SUBJECT: NuScale Power, LLC Response to NRC Request for Additional Information No. 361 (eRAI No. 9285) on the NuScale Design Certification Application

NuScale Response to NRC Request for Additional Information eRAI No. 9285

eRAI No.: 9285

Figure 11.4-2a: Process Flow Diagram for Wet Solid Waste Air Sparging Operation

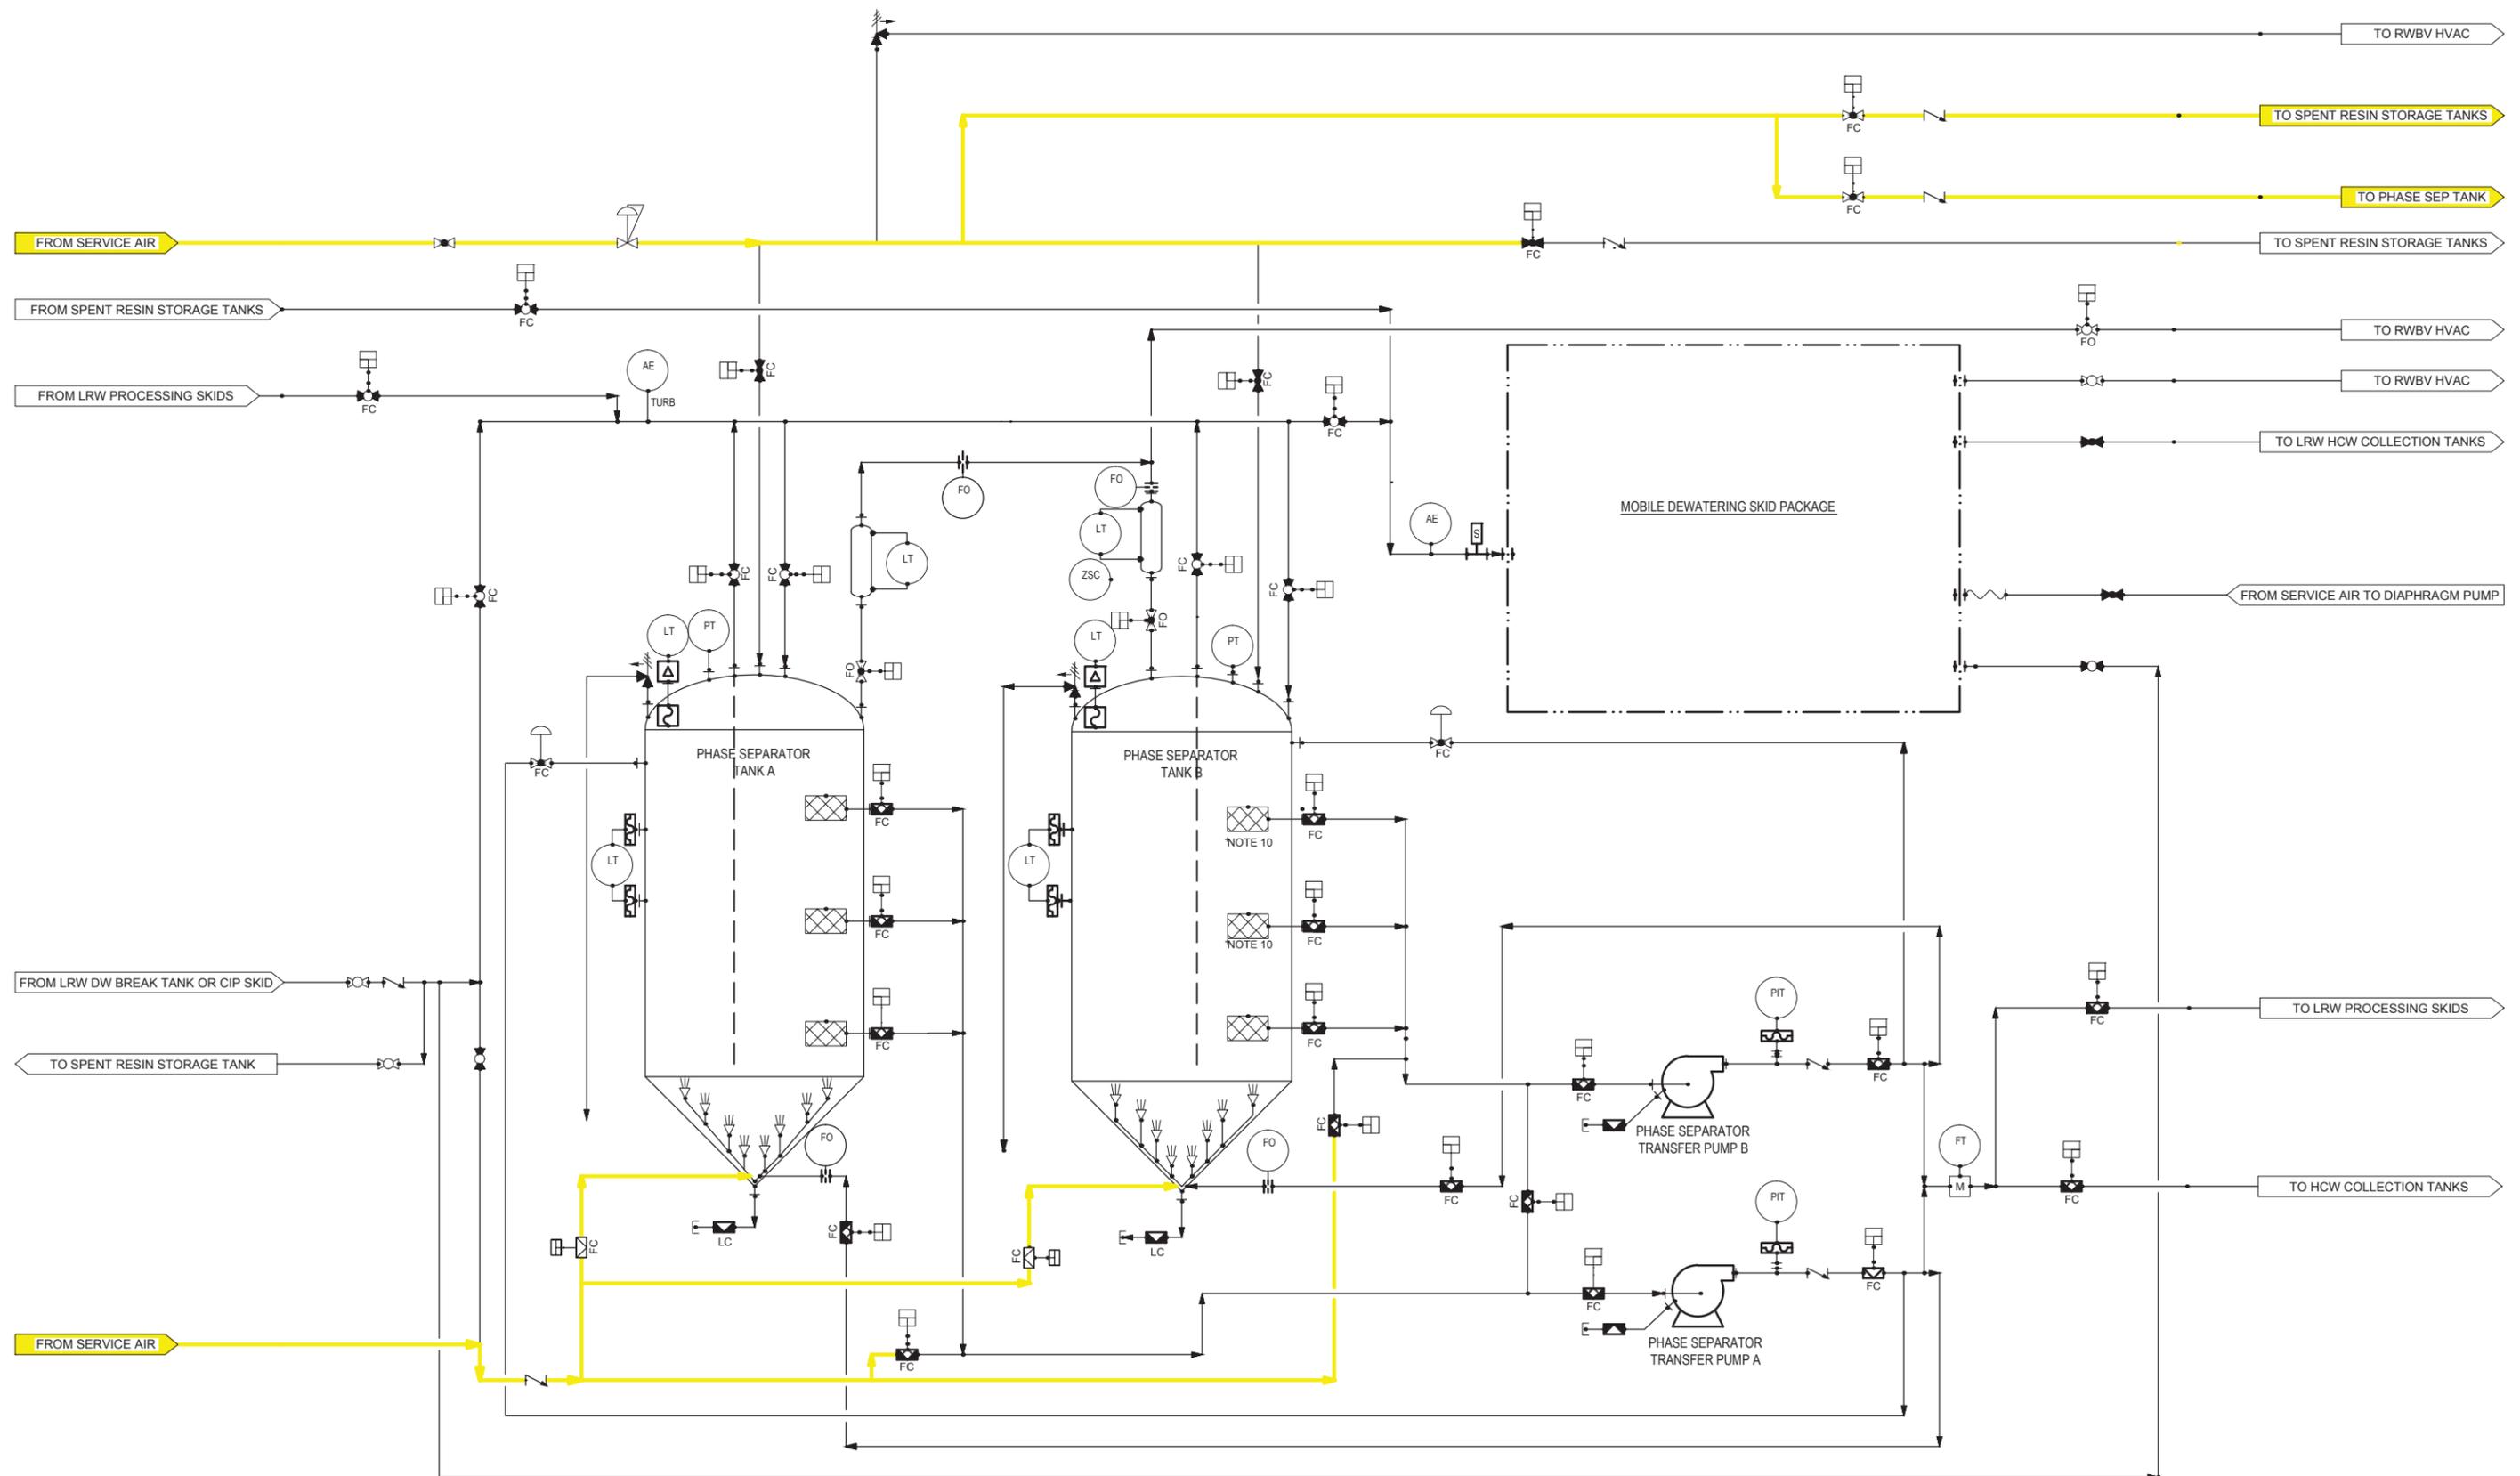
“Solid Radioactive Waste System Diagram,” show a line from the Service Air system that is separated from the suction of the resin transfer pumps by a single isolation valve. The use of a single isolation valve increases the risk for air intrusion due to valve leakage or misalignment. Based on information made available to the staff during the RPAC Chapter 12 Audit, the suction isolation valves for the pumps appear to be diaphragm disk valves. This information appears to be consistent with DCD Section 11.4.2.5.3, “Piping and Valves,” which states that valves in slurry transfer lines are full-ported ball valves and liquid process valves are diaphragm valves. Operating experience is available (e.g., Electric Power Research Institute (EPRI) Technical Report (TR) 105852 Volume 1 “Valve Application, Maintenance, and Repair Guide,”) to the staff that indicates that leaks past seats of these types of valves can occur as a result of poor stem travel adjustment, diaphragm age and over setting the stem travel. Typically, these types of valves are not in a periodic performance testing (i.e., leakage testing) program, and the staff has not seen any information that indicates that they are in a performance testing program.

To prevent air intrusion into the SRWS transfer pumps, the service air is isolated from the suction side of the transfer pumps by at least two valves. To illustrate the separation of service air from the transfer pump suction, FSAR Figures 11.4-2a and 11.4-2b are annotated with yellow and blue colored lines to show the system configurations during an air sparging operation and a transfer pump operation.

For the air sparging operation figures, the yellow colored lines indicate the pipes that will be filled with service air during an air sparging operation. It can be seen that there are two isolation valves between the service air and the transfer pump suctions. This mode of operation is expected to be infrequent.
